2007–2010 Suzuki SX4 2.0 L4 Gas Engine Piston Replacement Compressor: 6512734

TECH TIP

#224

6512734
Piston Replacement

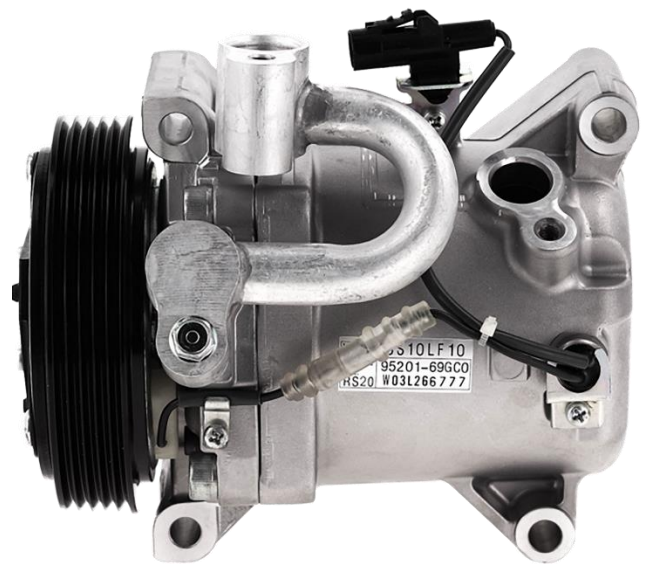
You may have noticed the gpd compressor for the 2007–2010 Suzuki SX4 2.0 L4 looks different from the OEM. We have improved the design to make it more reliable and reduce failure rates.

The original rotary vane design is prone to malfunction if not used. Over time, the vanes get stuck in the guides, which hinders the compressor from creating pressure. This issue results in complete compressor failure. Another common issue with a rotary vane compressors, is not priming before installation. By simply not rotating the clutch to ensure the oil has completely coated the vanes, the compressor can fail on the first run of your A/C.

gpd has redesigned the original vane design into a piston compressor (6512734) for this application. gpd's piston replacement compressors are designed to overcome the need to 'prime' the compressor. The redesign also overcomes any issues with lack of use. gpd's piston replacement design keeps the compressor lubricated year-round for better performance and longevity. It looks different, but is a direct bolt on, bolt off replacement.

When installing the redesigned compressor, only partially tighten the mounting bolts. Then attach your suction and discharge lines before finally tightening down all the bolts. This will help ensure the installation goes smoothly.
